RE: EPC SF2219 – Mayberry Filing 3 Drainage Report Comment Response

MAYBERRY, COLORADO SPRINGS – FILING NO. 3

**R&R JOB #MC22110
EPC PROJECT No. SF2219**

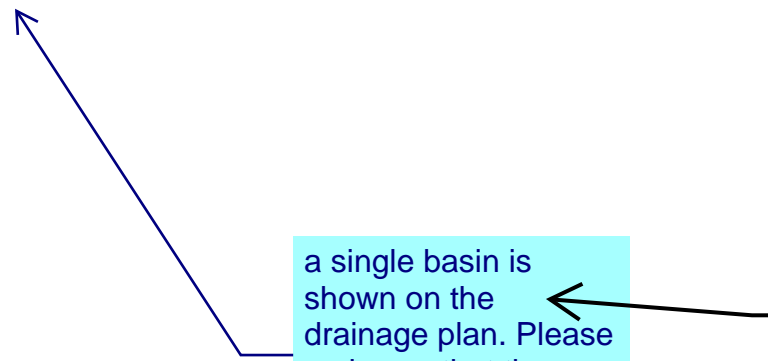
a single basin is shown on the drainage plan. Please revise so that they are consistent with each other.

these calculations and the map have been coordinated for this submittal

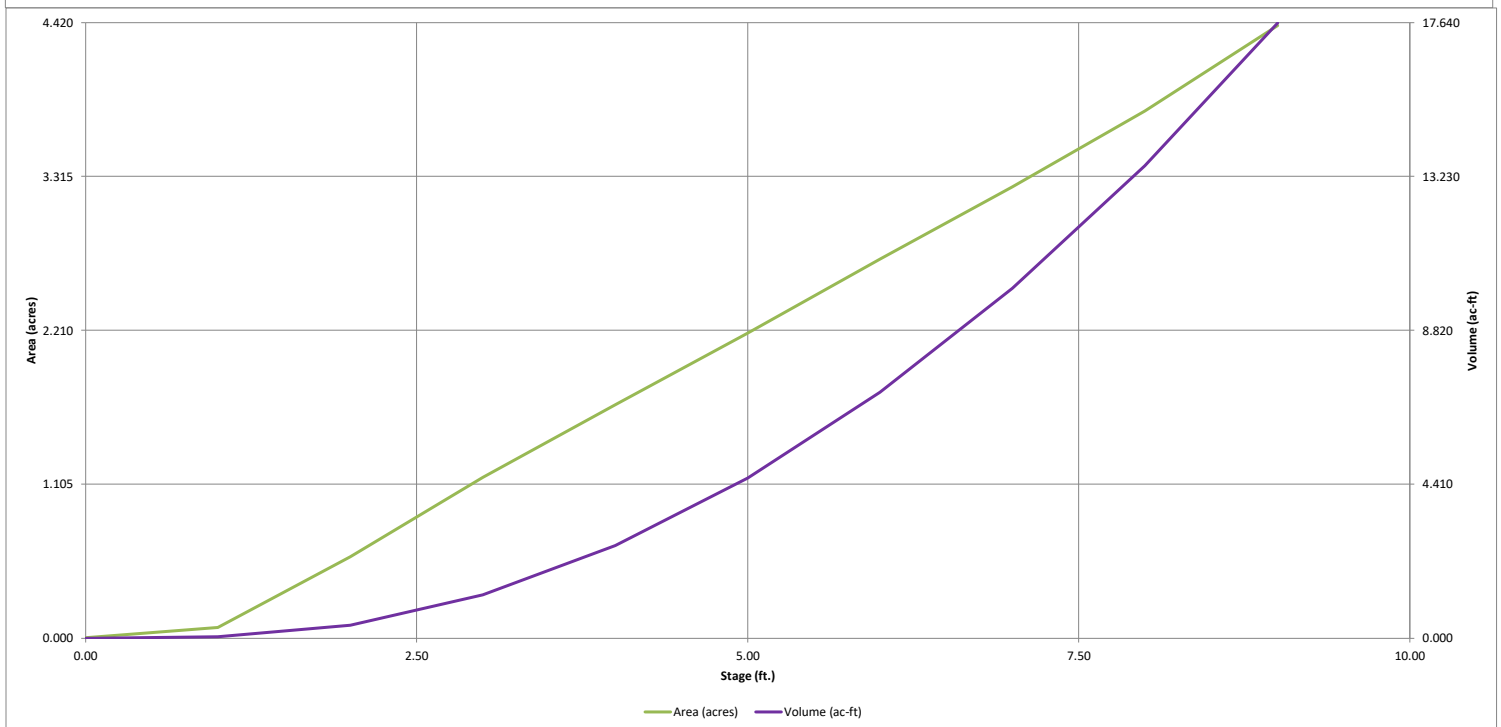
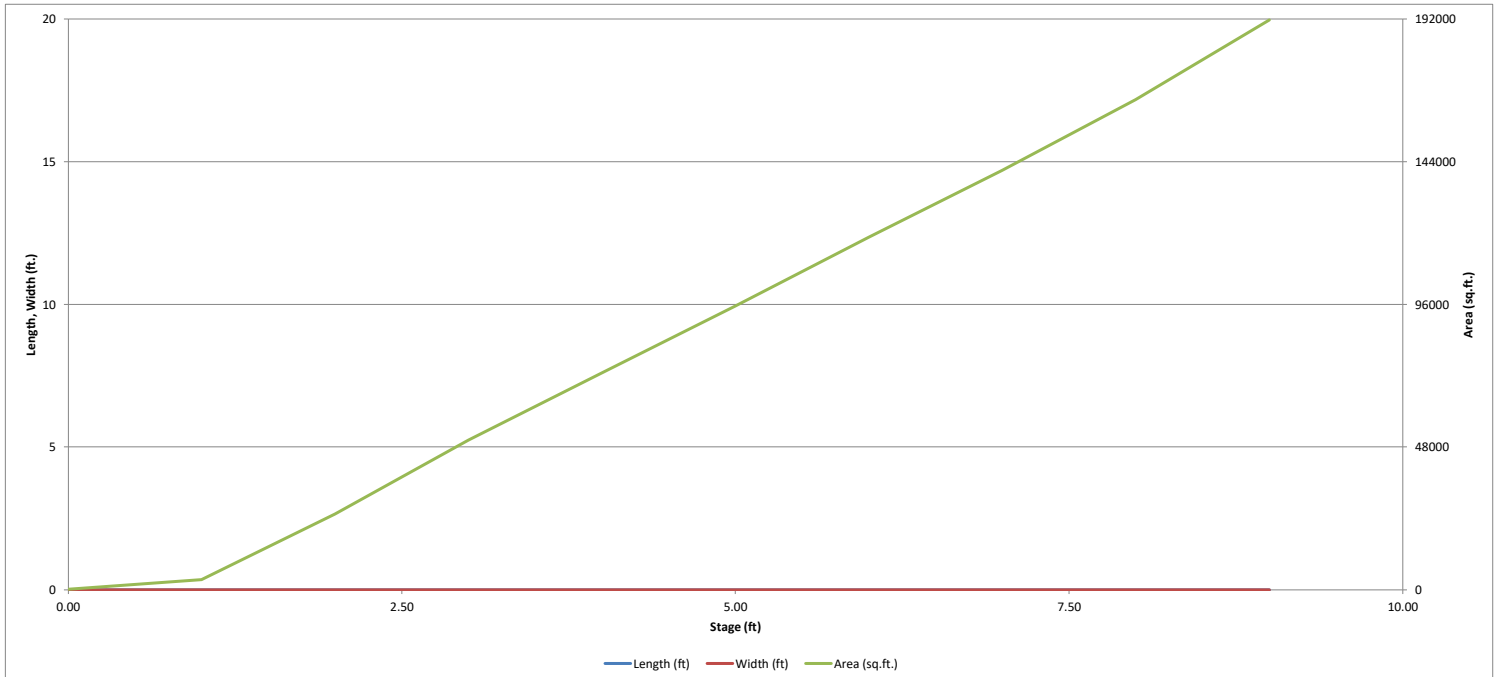
5 yr release rate?

revised, should say 100 year

INLET IN A SUMP OR SAG LOCATION

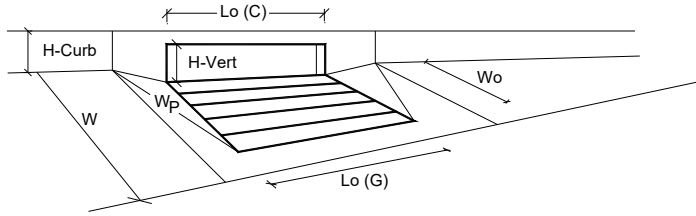
I ran the calculation using an older MHFD version and the latest 5.02 and it appears that a 15' inlet may work. Please verify/revise the calc. accordingly.
